Vehicle Safety Recall - Technical Service Bulletin

Attention: McNeilus Product Owner
Subject: Mixer Vertical Chute Rack for Steel or Aluminum Chutes
Models Affected: All Mixers
Date: May 2014

Vertical Chute Rack and Chute Stop Inspection and Replacement Procedure

VSR-TSB-003 VIN List
(NHTSA 14V-135)

Figure 1: “Old” Style Chute Rack **does not need to be replaced**. On left is the three chute rack design, and on the right is the two chute rack design.

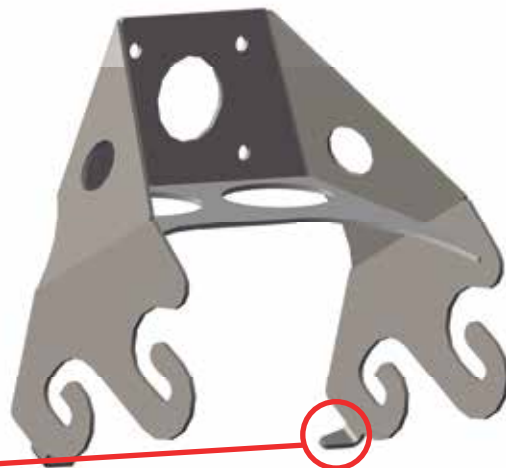
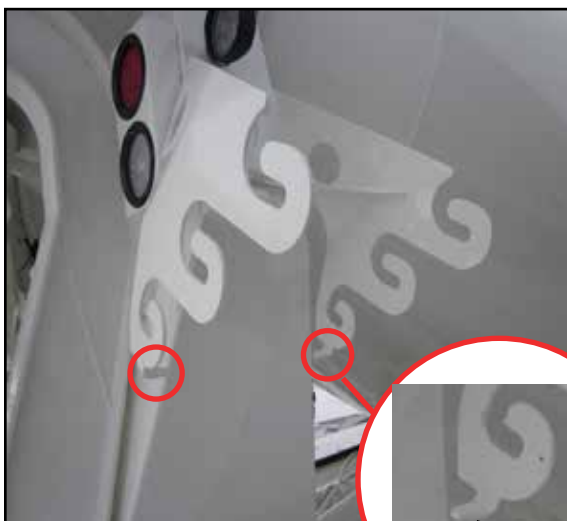
- If the chute rack looks like Figure 1, the rack is acceptable and no action is required (“old” chute rack style). The truck may be returned to service. (Note: Images for both the two chute rack design and the three chute rack design are provided.)

- If the chute rack looks like Figure 2, the rack must be replaced (“recalled” chute rack style). (Note: Images for both the two chute rack design and the three chute rack design are provided.)

- An obvious difference between the old chute rack style and the recalled chute rack style is that the recalled chute rack has two bent tabs on the bottom rack (Figure 2).

Figure 3: NEW chute rack designs (1503879 for the 3 chute design, 1504170 for the 2 chute design).

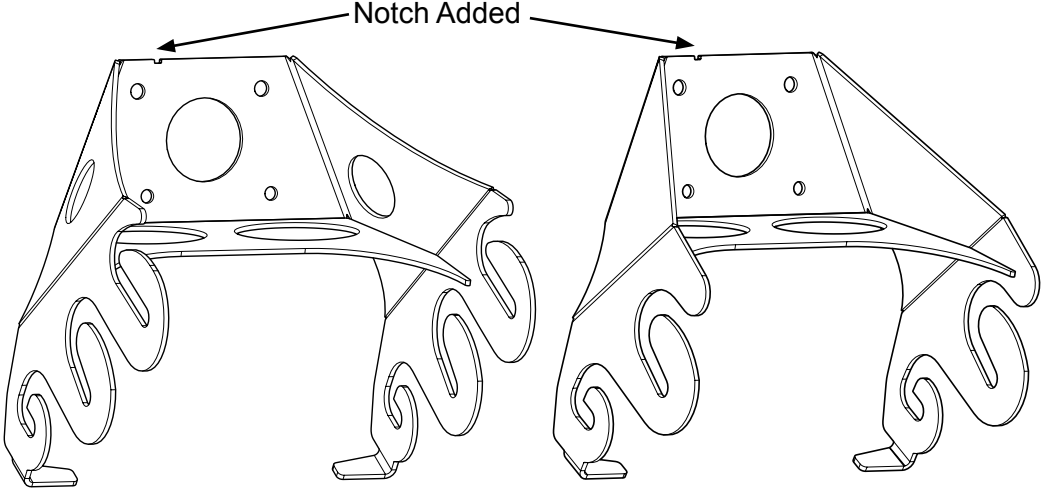
Figure 3 shows the NEW style chute rack designs (1503879 or 1504170) that will replace the “recalled” designs.

2. Install and align the new chute rack, **P/N 1504170 for the two chute rack design** or **P/N 1503879 for the three chute rack design**, on the truck in the same location from which you removed the existing chute rack.

Figure 6: Place and secure the new chute rack on to the truck with the provided hardware. On left is the three chute rack design, and on the right is the two chute rack design.

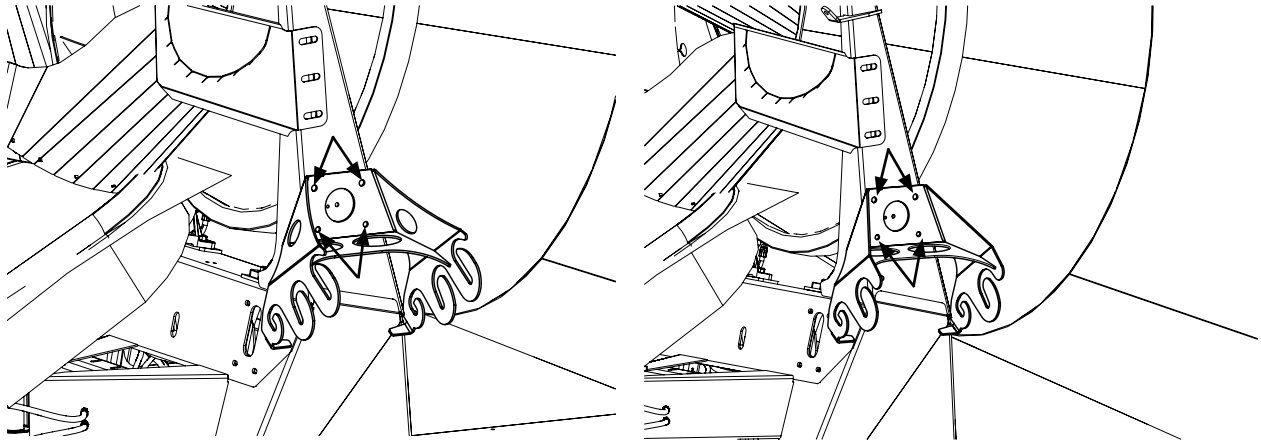
3. Secure the new chute rack on the truck using the new hardware provided: (4) P/N 1164989 Bolts, (4) P/N 0120202 Nuts. See Figure 6 for securing location of the chute rack on the truck (the three chute rack design is shown in Figure 6 for illustrative purposes. Install and attach P/N 1504170 for the two chute rack design in the same manner).

Figure 7: Place and secure the new offset chute stops on to the truck with the provided hardware.

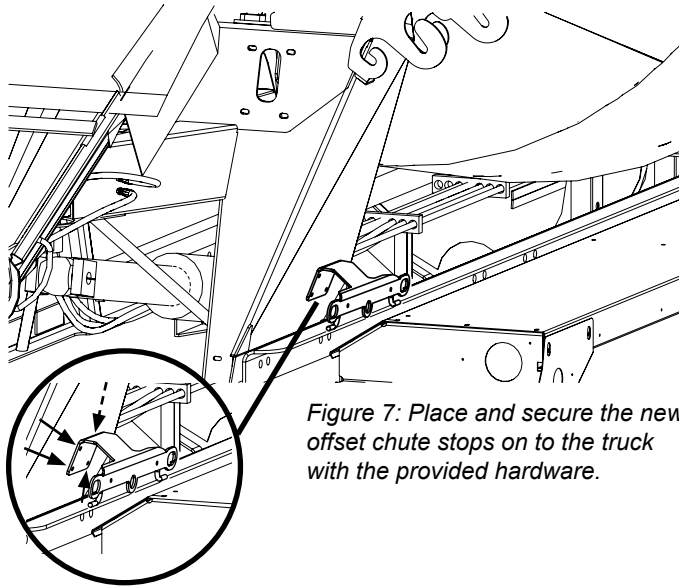
1. Remove the existing offset chute stop by removing the mounting hardware that secures the chute stop to the truck. Discard the existing chute stop and hardware.
2. Install and align the new offset chute stop (P/N 1503170) on the truck in the same location from which you removed the existing chute stop (Figure 7).
3. Secure with the new hardware provided: (4) P/N 1243670 Bolts, (4) P/N 0120200 Nuts (Figure 7).
